Project: **Proposed 38-Lot Woods at Viewcrest Plat**
352 Viewcrest Road, Bellingham, WA

Subject: **Memorandum #2 – Response to Public Comment & COB RFI (Issued 8/14/2024)**

Figure 1

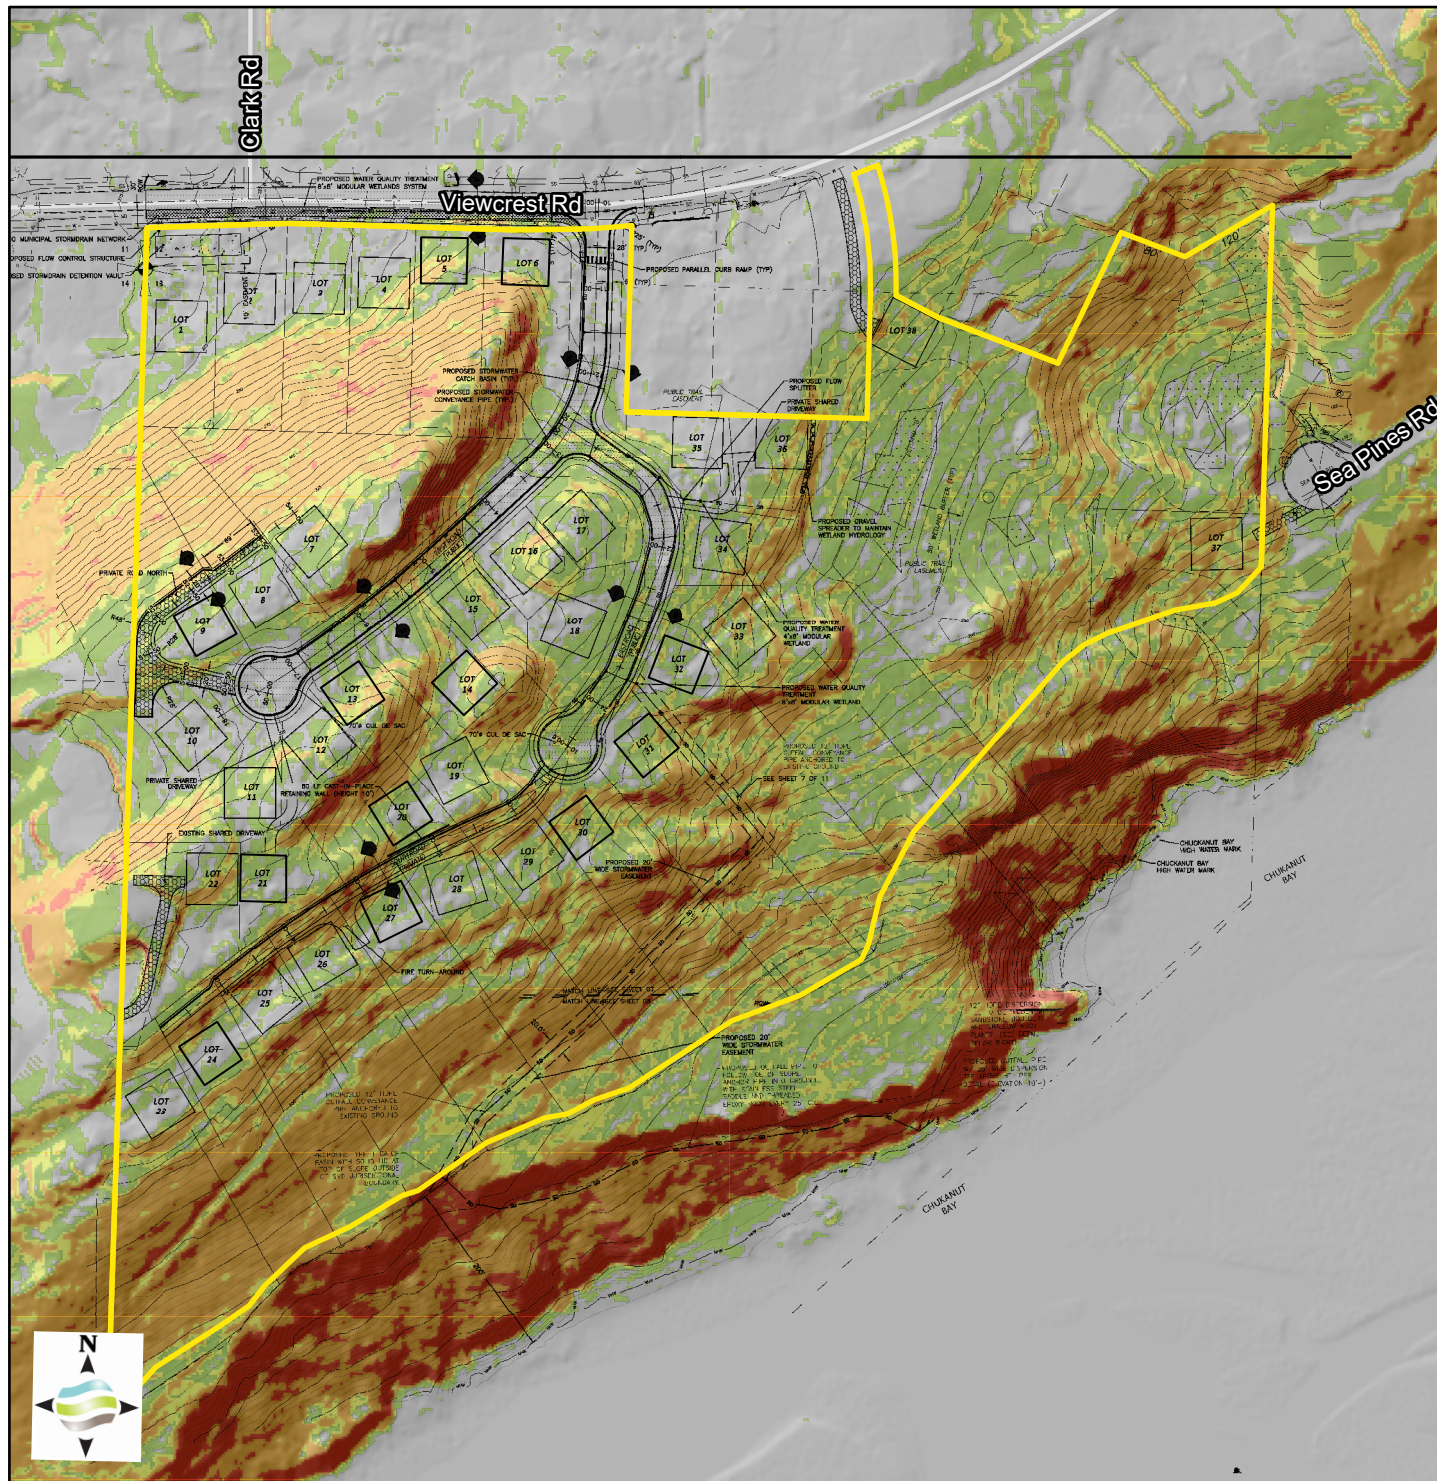
We recognize that difficulties on confirming building envelopes or questions on buffer verifications result from the combination of the project extent, scale of maps, and iterative design process concurrent with and influenced by our work. Please refer to Figure 1 of the *Geohazard Review Addendum* (2024), attached for reference, as well as the most recent plat plans for current depiction of the proposed layout with respect to site conditions. We have also produced a series of exhibits to provide a detailed view of specific lots and areas where the buffer compliance is not obvious from review of the full site maps. The assumed building envelopes are 60' x 60' square (blue outline) pursuant to BMC 23.08.060.D.1 for new lot creation. Orange outlines are 54' x 54', representing a 10% reduction (permitted as a departure pursuant to BMC 23.48.030.C.2.b).

LOT 6 - GEOLOGICAL CRITICAL AREAS EXHIBIT

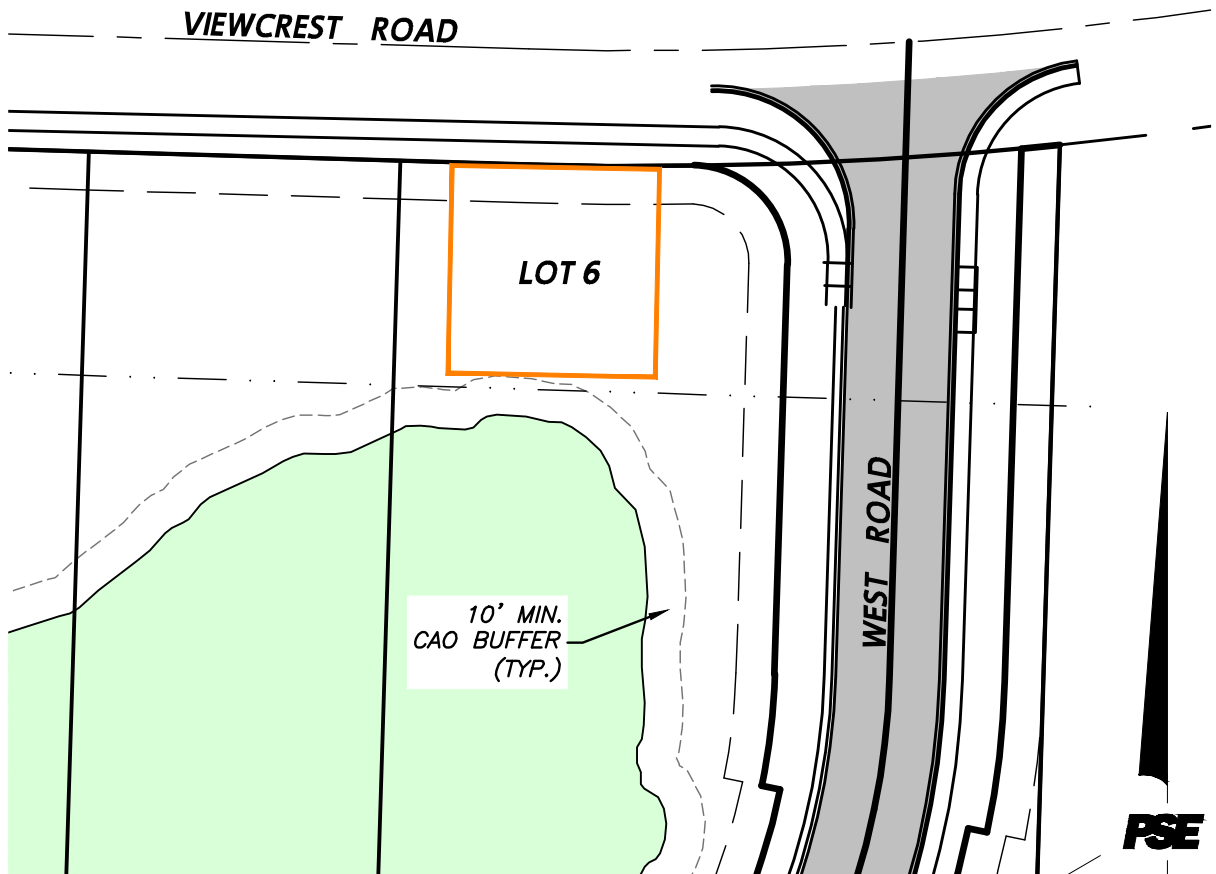
- Lot 6 building envelope is shown to be outside of the minimum 10-foot CAO buffer (Sheet 1). The remaining northwest lots (1 to 5) are >10 feet from the delineated geohazard slope area (green).

LOT 7 - GEOLOGICAL CRITICAL AREAS EXHIBIT

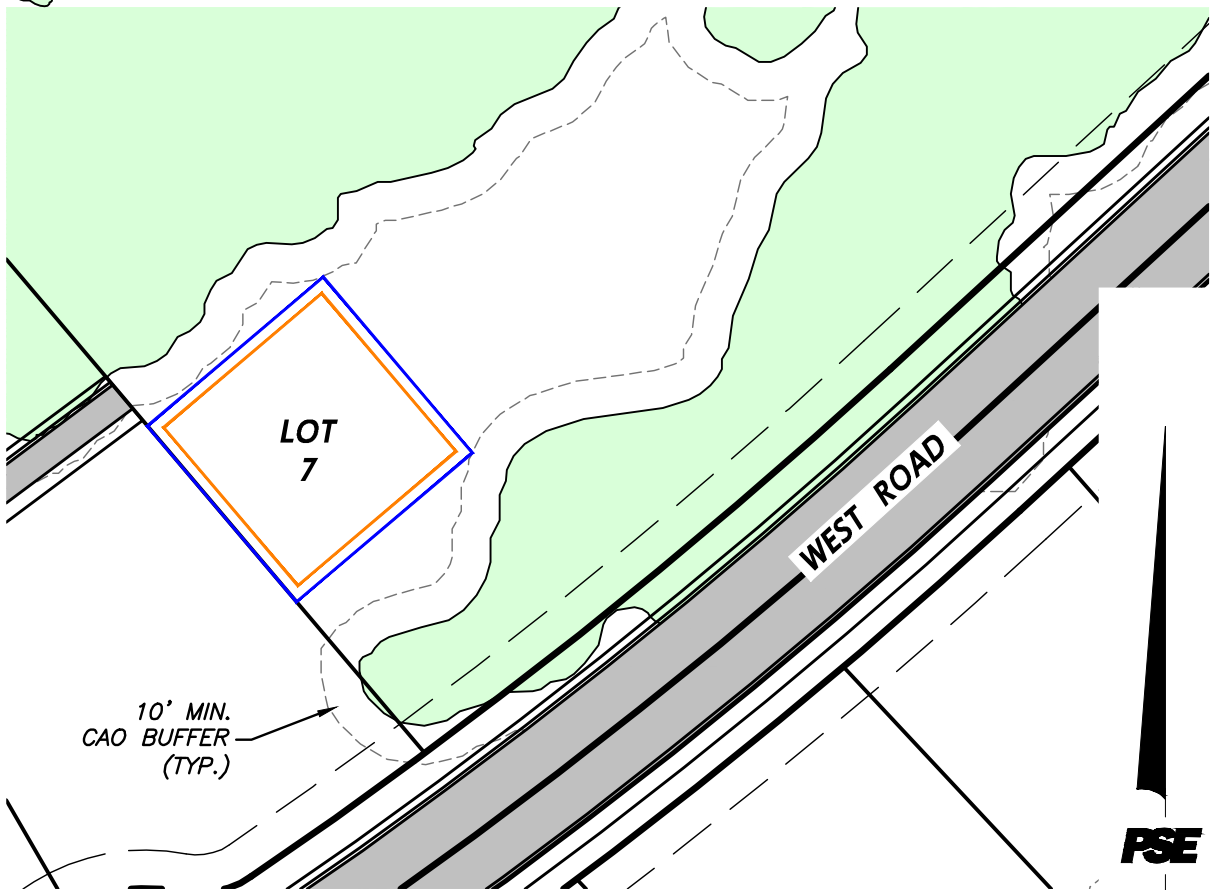
- Lot 7 is shown to be outside of minimum buffers to the northwest and southeast (Sheet 2). In addition, we re-verified the building envelope is over 20 feet from the nearest steep rock exposure to the east (per 2022 Geotech report recommended setback).

LOT 14 - GEOLOGICAL CRITICAL AREAS EXHIBIT

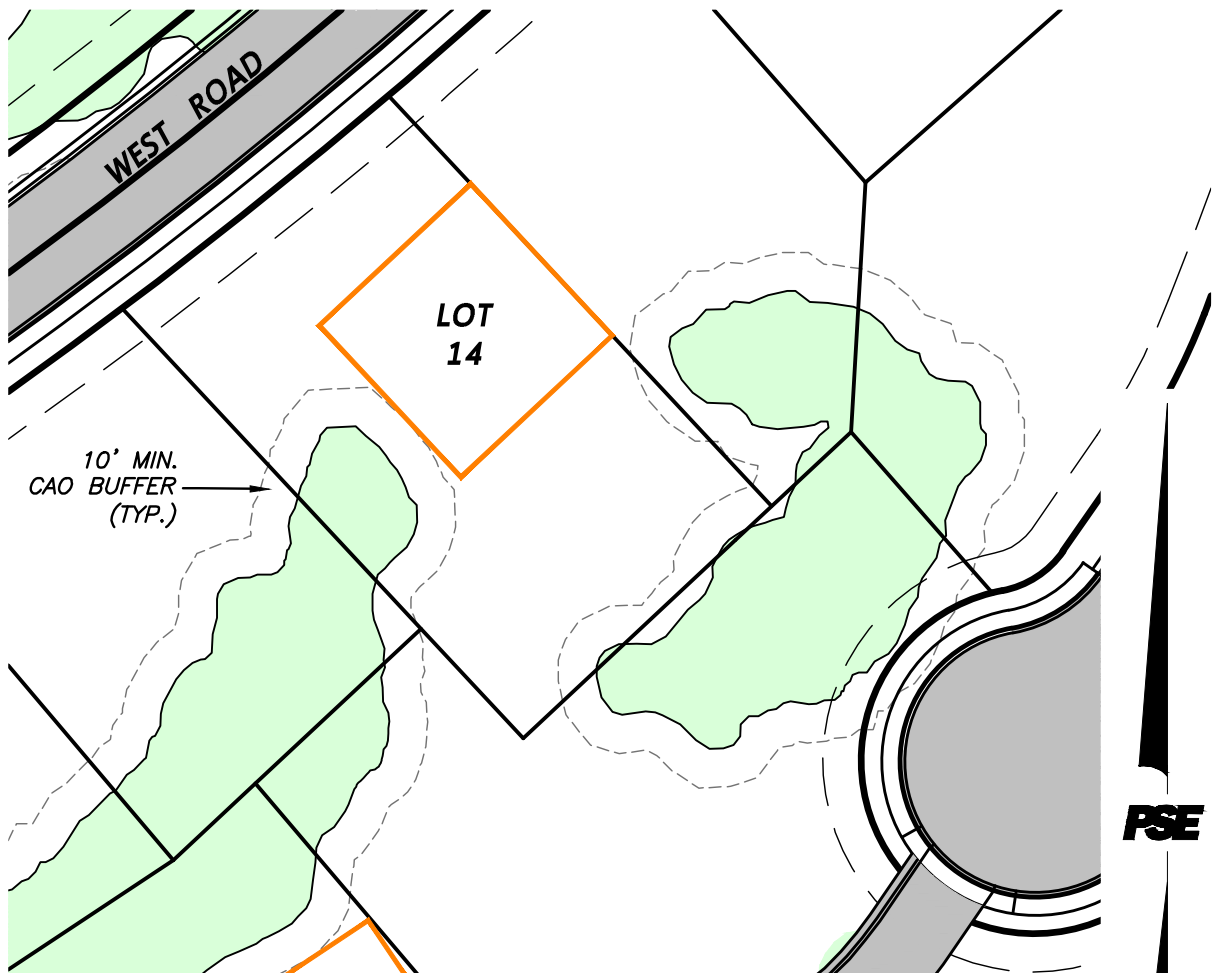
- In the west-central area, Lots 14 (Sheet 3) and 20 (Sheet 4) are shown outside of the 10-foot minimum buffers.
- Lots 24 through 33 are shown on Sheets 5 to 7 to be outside of the 10-foot buffers from the downhill slope and side-slopes delineated as geohazard areas.

LOT 38 - GEOLOGICAL CRITICAL AREAS EXHIBIT

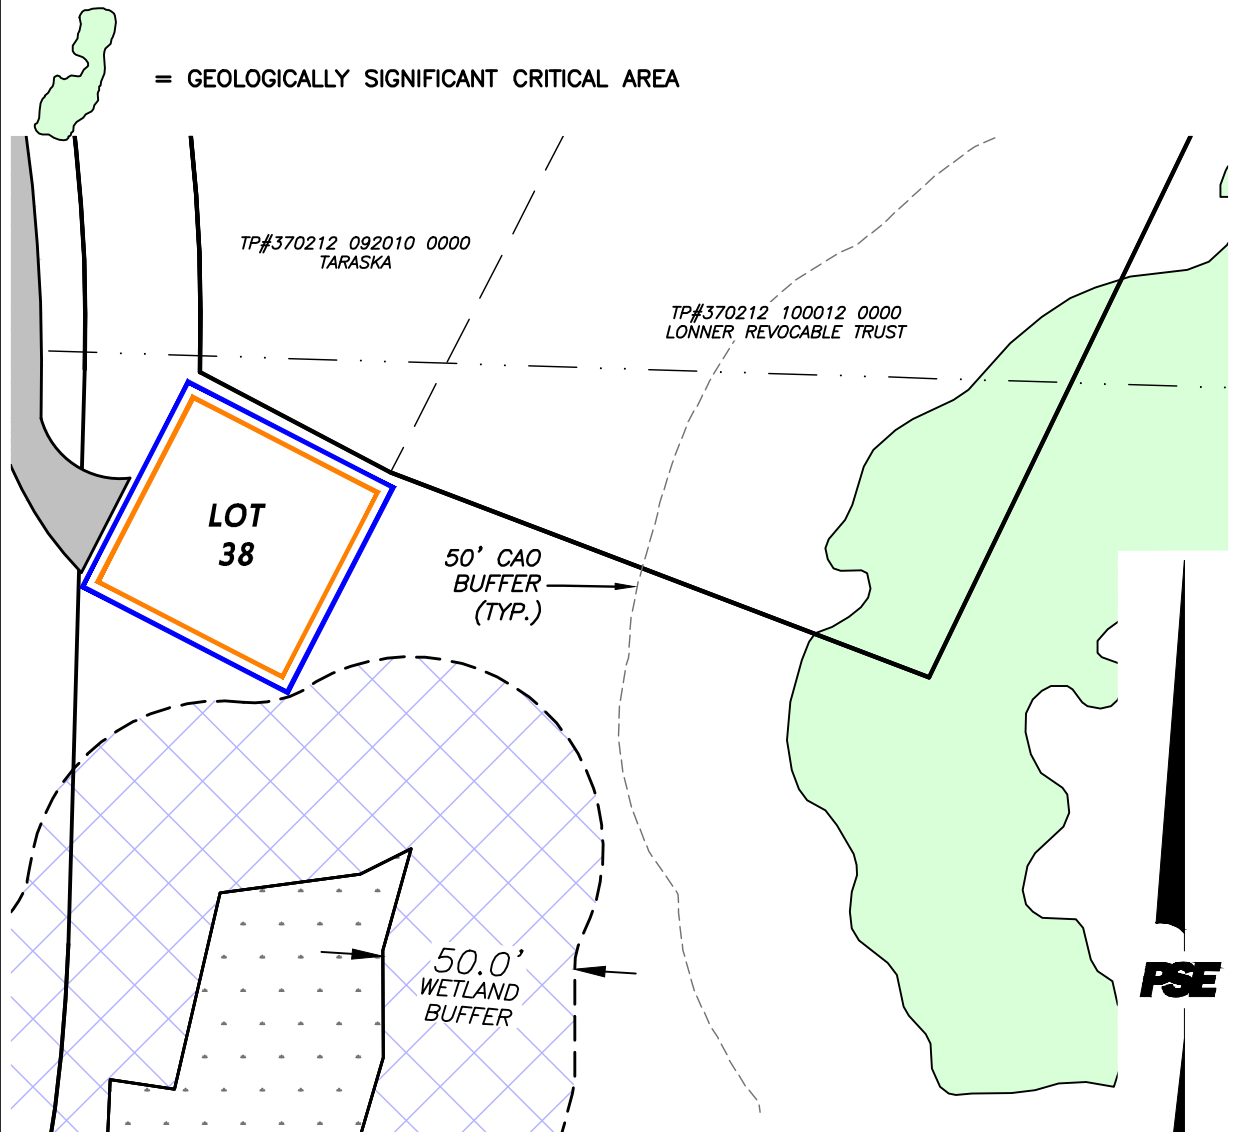
- Lot 38 is shown to be substantially outside of the code standard 50-foot buffer assumed for the northeast slope area. Actual distance is over 100 feet.

COASTAL GEOLOGICAL CRITICAL AREAS EXHIBIT

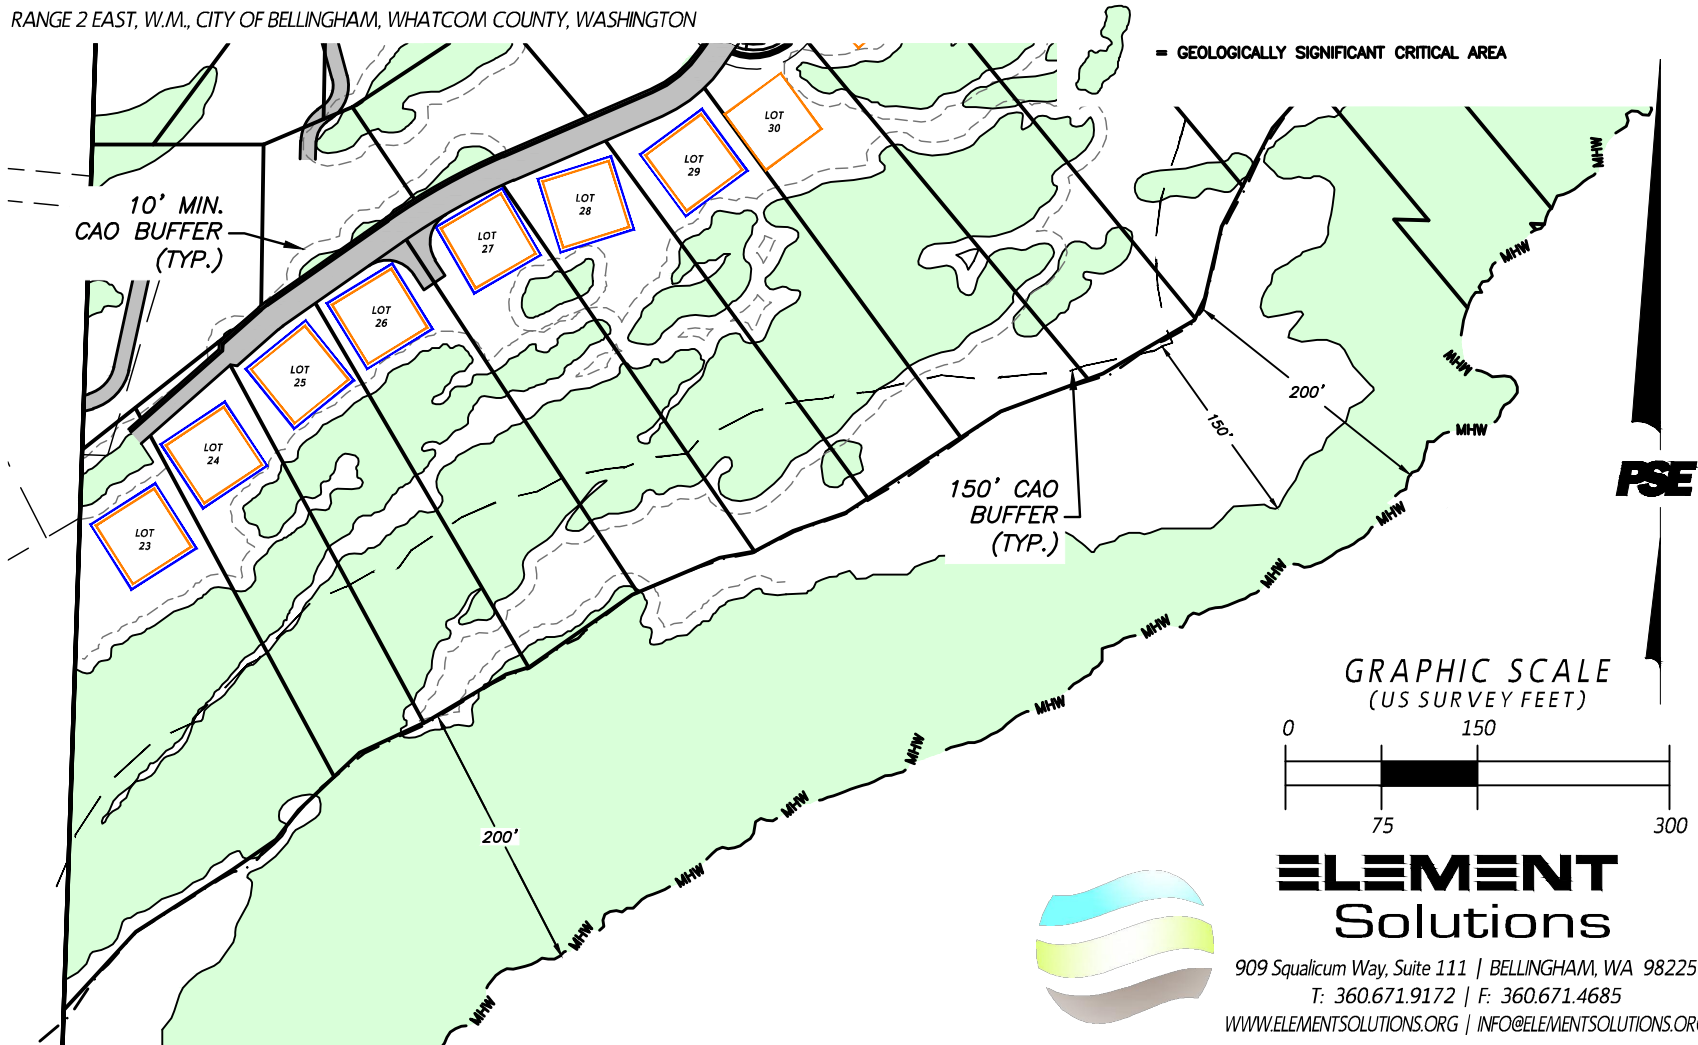
- Sheet 9 illustrates the coastal bluff slope buffer (150 feet assumed per 2022 Geotech report). All lots are well outside of this recommended extent from the top of the southeast bluff.
